Service Information

Retrofit heat protection mat to coolant lines

0011450300

F06 F10 F12 F13 S63T

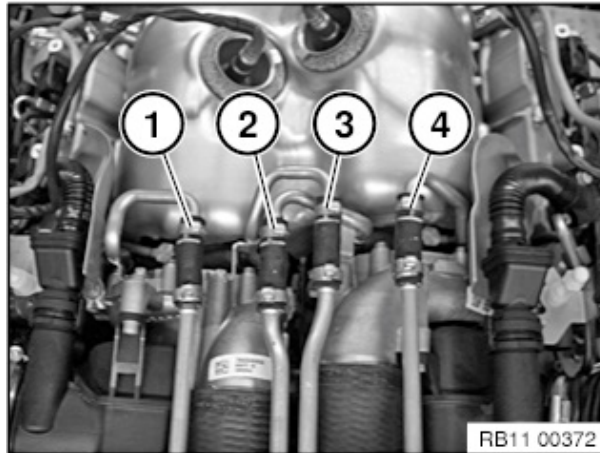
The component temperatures near the coolant lines on the exhaust turbocharger are too high. This may cause the hose elements to leak.

Retrofit heat protection mats to the coolant lines.

- To remove the engine cover, see Repair Instructions **RA 11 12 090**.
- Place one heat protection mat around each of the four hose elements of the delivery and return lines and seal them.
